Manual Supplement

Manual Title:	744 Users	Supplement Issue:	9
Part Number:	691287	Issue Date:	3/15
Print Date:	September 1998	Page Count:	10
Revision/Date:	1, 2/99

This supplement contains information necessary to ensure the accuracy of the above manual.

Figure A. Sourcing Temperature using Drywell

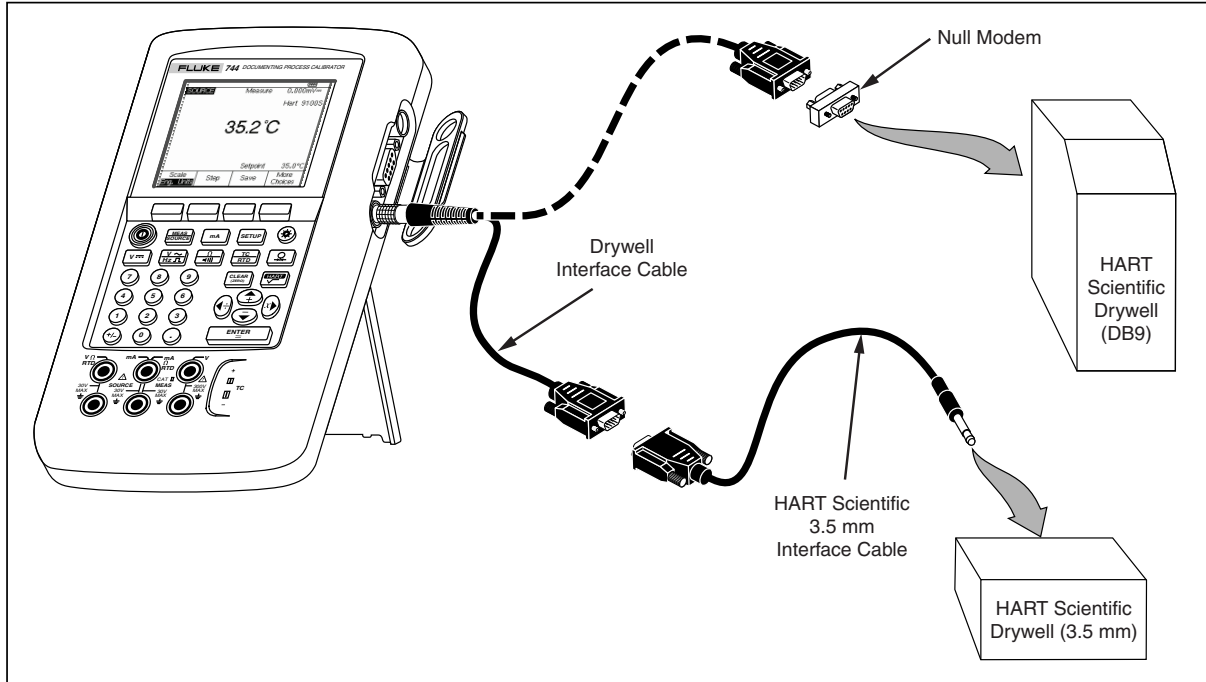
On page 59, before **Source Scale**, add the following:

Connect the 744 to the drywell by plugging the drywell interface cable into the pressure module connector as shown in Figure A. If the drywell has a DB9 connector, plug the drywell interface cable directly into the drywell using the DB9 Null Modem adapter. Drywells with the 3.5 mm jack connector need to use the serial cable supplied with the drywell in addition to the 744 drywell interface cable. Join the DB9 connectors of the two cables, and connect the 3.5 mm jack to the drywell.

Be sure the drywell is configured for serial communication at 2400, 4800, or 9600 bits per second. Other rates are not supported by the 744.
